PCN Date: 21-AUG-23

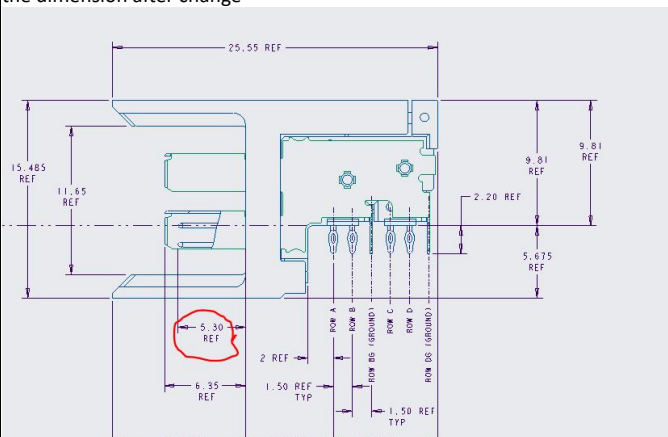
update the customer drawing, update the DIM N to 5.3mm.

the dimension before change
